Economic Commission for Europe**Inland Transport Committee****World Forum for Harmonization of Vehicle Regulations****Working Party on Lighting and Light-Signalling****Sixty-eighth session**

Collective Amendments: Regulations Nos 3, 6, 7, 48, 77 and 91**Proposal for collective amendments to Regulations Nos. 3, 6,
7, 48, 77 and 91****Submitted by the experts from the Working Party “Brussels 1952”***

A. Proposal for Supplement 11 to the 04 series of amendments to Regulation No.48

Figure (see paragraph 6.5.)

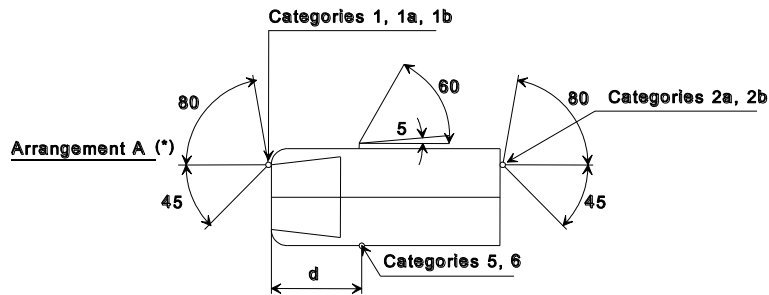
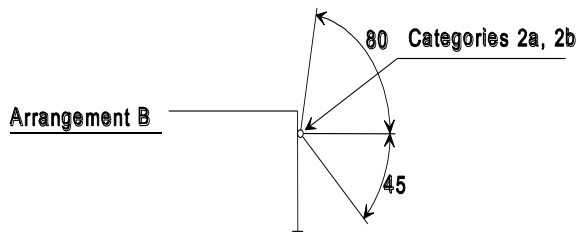
For M_1 and N_1 category vehicles, the value of 45° inward for the direction indicator lamps of categories 1, 1a or 1b, whose lower edge of the apparent surface is less than 750 mm above the ground, may be reduced to 20° under the horizontal plane containing the reference axis of this lamp.

For the direction indicator lamps of categories 1, 1a, or 1b, 2a and 2b mounted below 750 mm (measured according to the provisions of paragraph 5.8.1), the inward angle of 45° may be reduced to 20° under the H plane.

6.5.5.2. or, at the discretion of the manufacturer, for M_1 and N_1 category vehicles: Front and rear direction indicator lamps, as well as side-marker lamps (**).

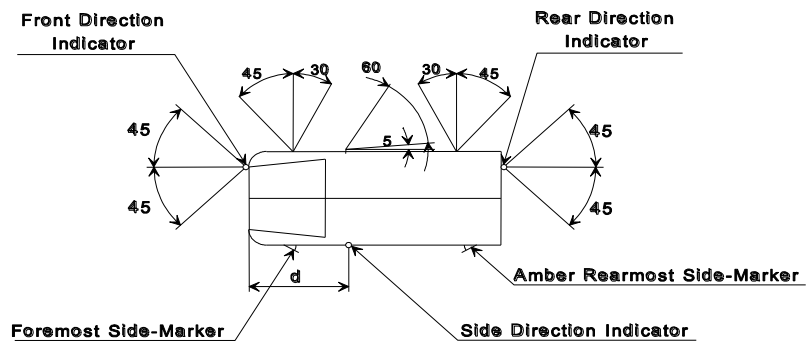
The value of 45° inward for the direction indicator lamps of categories 1, 1a or 1b, whose lower edge of the apparent surface is less than 750 mm above the ground, may be reduced to 20° under the horizontal plane containing the reference axis of this lamp.

However, for the direction indicator lamps of categories 1, 1a, or 1b, 2a and 2b mounted below 750 mm (measured according to the provisions of paragraph 5.8.1), the inward angle of 45° may be reduced to 20° under the H plane.

Add a new diagram and associated text, to read:

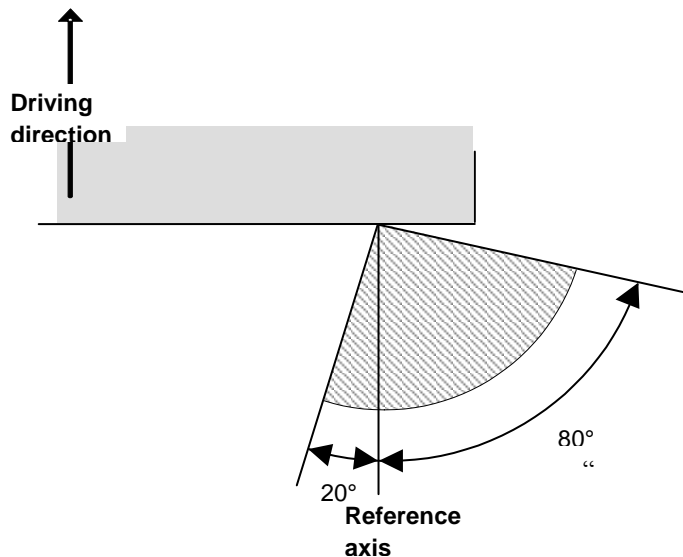
Under the H plane for lamps intended to be installed with this plane at a mounting height less than 750 mm above the ground.

Add a new diagram and associated text, to read:

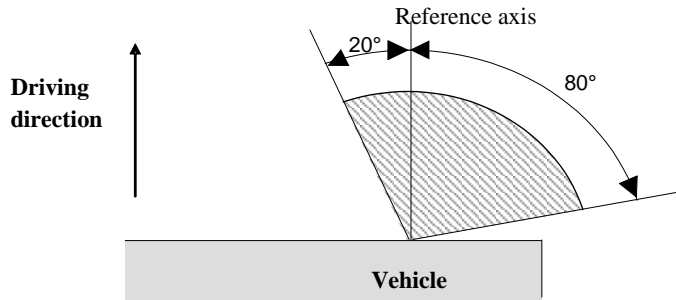
Under the H plane for front position lamps intended to be installed with this plane at a mounting height less than 750mm above ground.

Add a new diagram and associated text, to read:

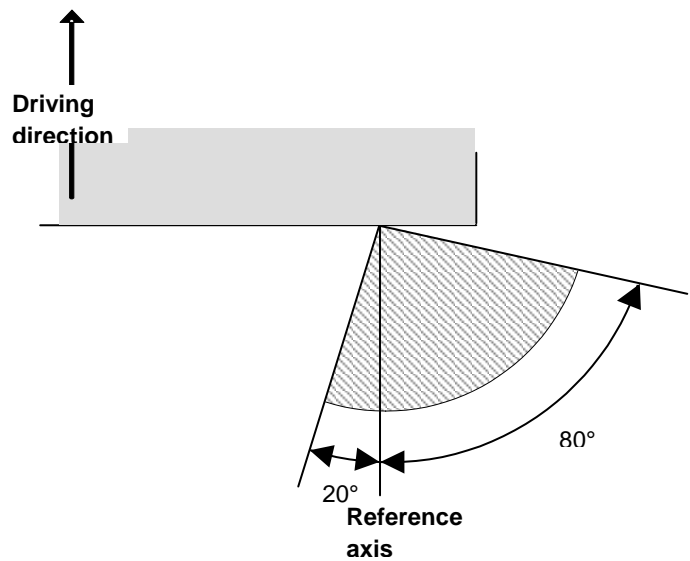
Under the H plane for rear position lamps intended to be installed with this plane at a mounting height less than 750mm above ground.

Add a new diagram and associated text, to read:

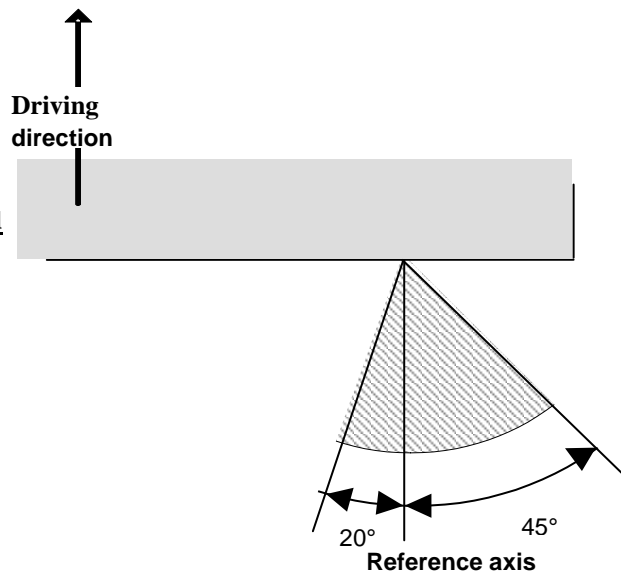
Under the H plane for stop lamps (S1 and S2) intended to be installed with this plane at a mounting height less than 750mm above ground.
